December 1, 2014

Docket ID No. EPA-HQ-OAR-2013-0602
Environmental Protection Agency
EPA Docket Center (EPA/DC), Mailcode 28221T
1200 Pennsylvania Avenue, NW
Washington, DC 20460
(submitted via regulations.gov)

Re: NRG's Comments regarding the Proposed Carbon Pollution Emission Guidelines for Existing Stationary Sources: Electric Utility Generating Units

Figure 1.

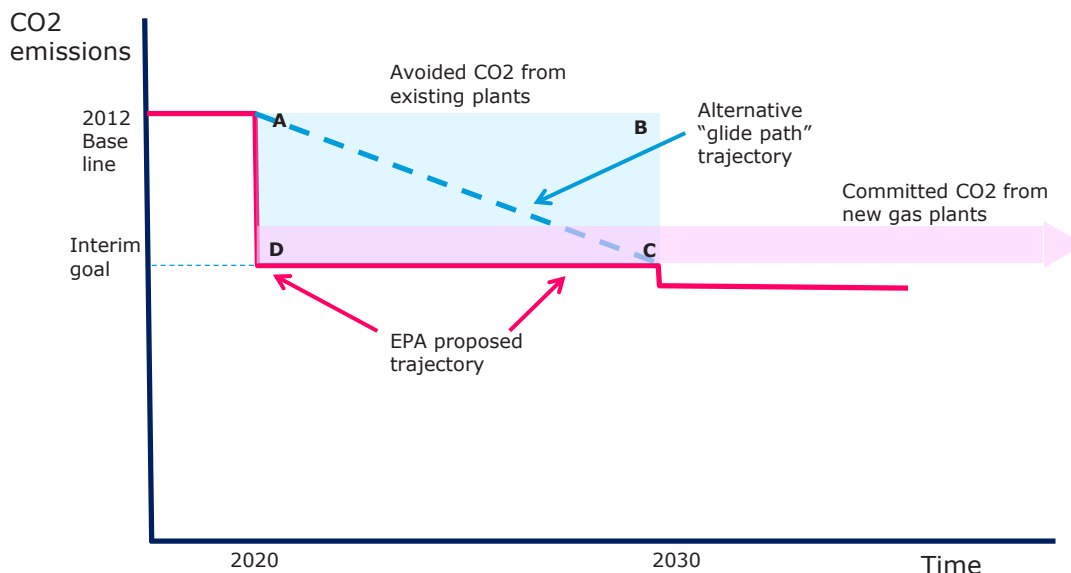
Figure 1 below illustrates how the EPA’s rule can be evaluated under this critical metric of the stock of emissions added to the atmosphere.

In this figure, the EPA’s typical emission reduction trajectory is shown as a red, stepped line. During the 10 years from 2020 to 2029, it would avoid CO2 emissions from existing power plants equal to the shaded rectangle ABCD. An alternative emission trajectory -- a true glide path -- is shown as the dotted blue diagonal line from A to C. This would avoid emissions equal to the triangle ABC, while allowing emissions equal to the triangle CDA during this ten year period. As can be seen, the AC glide path avoids only half as many emissions from existing plants as the EPA’s proposed abrupt trajectory would. Despite this, it may very well result in *lower* overall power sector CO2 emissions to the atmosphere.

This is because, as discussed above, the dramatic 2020 reductions due to the combination of EPA’s proposed interim goals and ten-year averaging constraint creates triple incentives -- reliability, market and regulatory -- for new natural gas combined-cycle power plant construction. These plants will operate, and emit CO2, for a considerably longer period than 2020 to 2030. Figure 1 shows this “committed CO2” from the new gas plants as the much longer, purple rectangle extending into the future. It is readily evident that even a relatively small annual amount of CO2 from new gas plants will, over enough time, exceed the CO2 emitted by existing plants during the glide-down period (the triangle CDA).

EPA's analysis, however, shows the rule would also add 23 GW of new combined-cycle gas, both for reliability and economic reasons. Assuming the new gas plants also operate at a 70% capacity factor – consistent with the EPA's assumption in setting the BSER -- while emitting 825 pounds of CO₂ per MWH, they will *add* 1.7 billion tons of CO₂ to the atmospheric stock during their expected 30 year lifetime. In terms of both total US CO₂ emissions and mitigating global warming, these added emissions mean the total emissions avoided by EPA's proposed trajectory would equal 3 billion tons – 1.7 billion tons or 1.3 billion tons.

The AC glide path for emission reductions, by contrast, would allow existing units to achieve reductions amounting to only half of the 3 billion ton reduction during the 10 year period (the triangle ABC). Assuming the coal plants that would otherwise retire due to the rule would face a similar reduction path as all existing plants, they would emit 1.5 billion tons more CO₂ under the glide-path during the ten year period than under the EPA's rule.²⁵ This means the CO₂ reductions from existing plants, under the glide path could be as low as 1.5 billion tons, conservatively estimated. Thus the new gas plants EPA predicts will be induced by the rule would add 1.7 billion tons of CO₂ to the atmosphere, substantially more than the 1.5 billion tons that could be added by using a true "glide path" approach to avoid the premature retirement of large numbers of coal plants.

Such systems – capable of ensuring the BES’s reliability and operating constraints are met, while supporting its continued de-carbonization, are the key to overcoming the inefficiency inherent in the Proposal. In terms of Figure 1, such a system allows the lifetime or committed emissions from new gas units to be minimized, thus achieving the lowest possible overall power sector emissions.
